# **Montgomery County Planning Board**

MCPB No. 22-055

Site Plan No. 820220120

ELP Bethesda at Rock Spring Phase 1B

Approved Fernwood Road Section along Marketing Center Frontage (from Rockledge Drive to Rock Spring Drive)

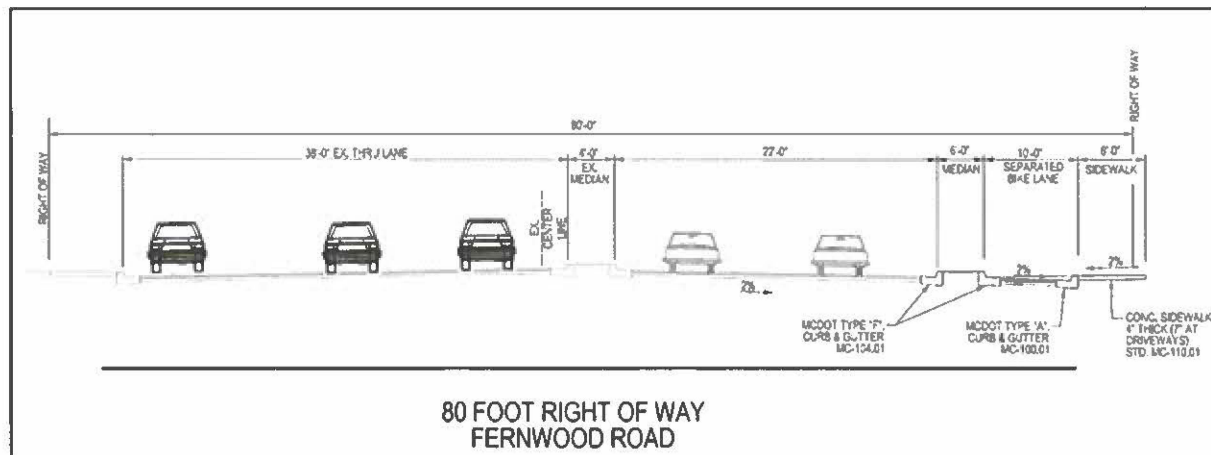
**Fernwood Road:** Fernwood Road is designated as a Business Street with planned Bus Rapid Transit, B-2, with a recommended 80-foot right-of-way from Rockledge Drive to Rock Spring Drive. The Applicant dedicated right-of-way to meet a consistent 80-feet along the entirety of the Fernwood Road frontage. In accordance with the Parking Lots to Places: Urban Design Guidelines for Rock Spring and White Flint 2 Sector Plans, the Applicant is in the process of constructing a ten-foot separated bike lane protected by a four-foot median. The segment of Fernwood Road directly adjacent to the marketing center is under construction to accommodate a six-foot planting strip between the bikeway and a seven-foot sidewalk, to facilitate the planting of street trees.
